# UNITED STATES PATENT AND TRADEMARK OFFICE

10/518,495

<b>Office Action Summary</b>	<b>Application No.</b> 10/518,495	<b>Applicant(s)</b> GRUPP ET AL.	
	<b>Examiner</b> LUCY P. CHIEN	<b>Art Unit</b> 2871

## **DETAILED ACTION**

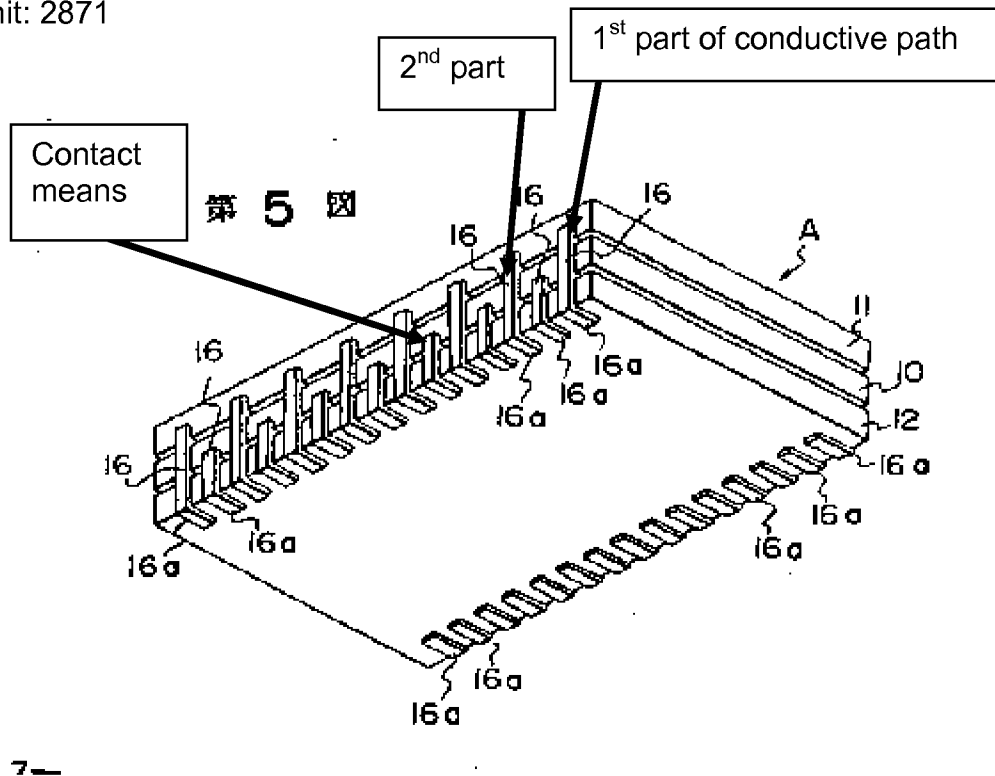
#### **Regarding Claim 14,31,33,35,37,**

Motai Atsushi discloses (Drawing 4 and Drawing 5) at least one transparent front substrate (11) whose top surface forms the front face of the cell; at least one back

substrate (12) that may also be transparent or not, whose lower surface(12) forms the back face of said cell; a sealing frame (15) joining the front (11) and back substrates (12) and defining a volume for retaining an electro-optically or photo-electrically active medium in a sealed manner (liquid crystal, (a)); said front and back substrates include on faces opposite each other at least one electrode each (13,14), these electrodes being connectable by conductive paths (16) of the cell to an electrical power or control circuit and the electrodes are flush (adjacent to, the electrodes (13,14) are shown to be at the edge of the substrates shown in Drawing 4) with an edge of the front substrate and with an edge of the back substrate respectively, and define lateral electric contact zones, wherein the conductive paths (16) are each formed of a first part in contact with the electrodes at the level of the lateral electric contact zones, and a second part (shown below) extending over the back surface of the cell, contact means (16a) (shown below) arranged at an exterior surface of the cell continuously or discontinuously over the edge, or the back, or the edge and the back, of said cell forming the electrical junction between the first and second parts of the conductive paths (16). The back substrate (12) is disposed between the contact means (16a) and the front substrate.

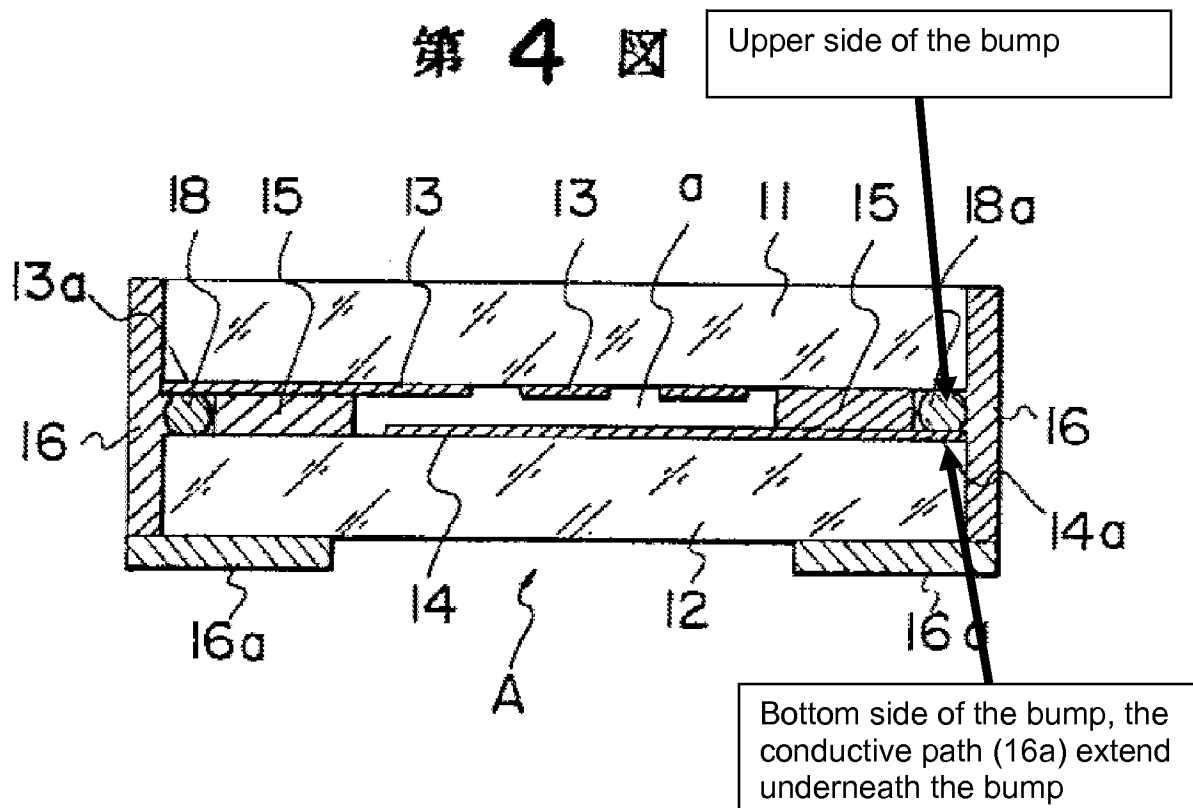
Motai Atsushi discloses (Drawing 4) wherein the contact means take the form of discrete bumps (lump of the first or second substrate).

Motai Atsushi discloses (Drawing 4) wherein the first parts of the conductive paths (16) come into lateral contact with the conductive bumps (18a), whereas the second parts of the conductive paths can extend as far as the top of said bumps and cover said bumps and the bottom substrate (12) in whole or in part.

Motai Atsushi discloses (Drawing 4) wherein the second parts of the conductive paths extend at least partially underneath the conductive bumps (see below).

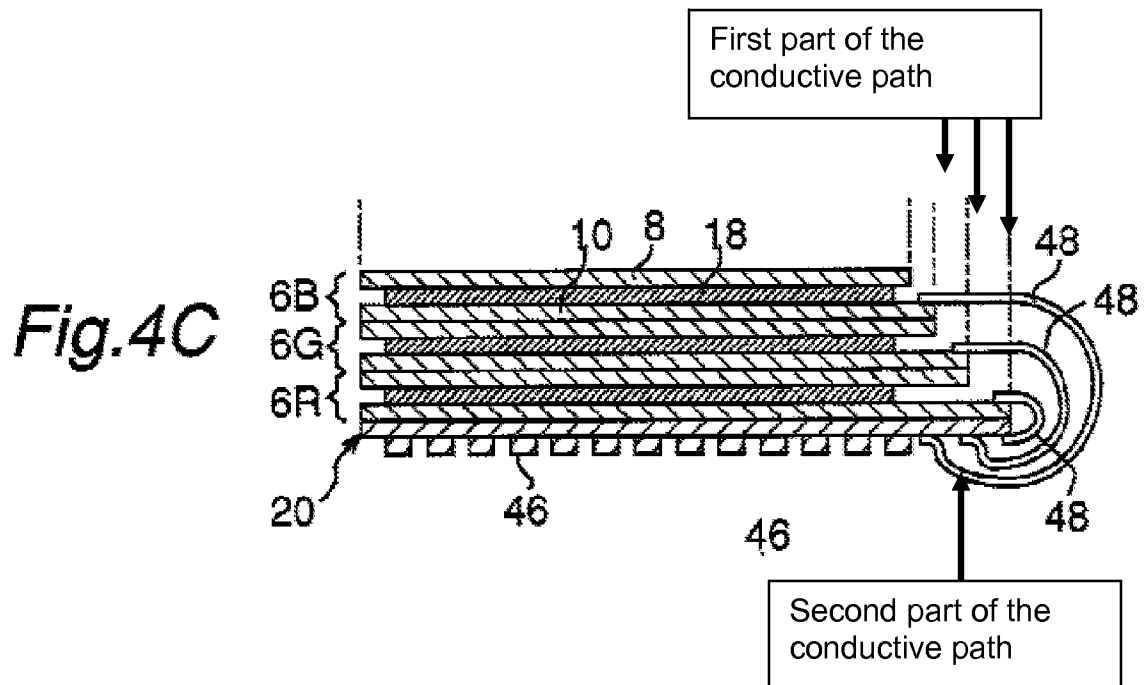
Mandai et al discloses (Fig. 1 and 4C) four superposed substrates (8,10) joined in pairs by sealing (16) frames which each define a sealed cavity for retaining liquid crystals (18); and a first sealing frame joining the substrates (16), while a second sealing frame joins the substrates and a third sealing frame joins the substrates, said substrates (8,10) including on their faces opposite each other at least one electrode (12,14) each, said electrodes being connectable by conductive paths (48) to an electric control circuit and the electrodes are flush (the electrodes (12,14) shown in Fig. 1 are at the edge of the substrate, therefore they are flushed with an edge of the front and back substrate) and define lateral electric contact zones, wherein the conductive paths (48) are each made up of a first part in contact with the electrodes at the level of the lateral electric contact zones (where 48 contacts the electrodes on the substrate), and a

second part extending over the back surface of the cell (shown below), contact means (can be interpreted to be one of the lines (48) arranged continuously of said cell forming the electric junction between the first and the second parts of the conductive paths. The back substrate (20) is disposed between the contact means (where the second part of the conductive path is pointing to) and front substrate (8).
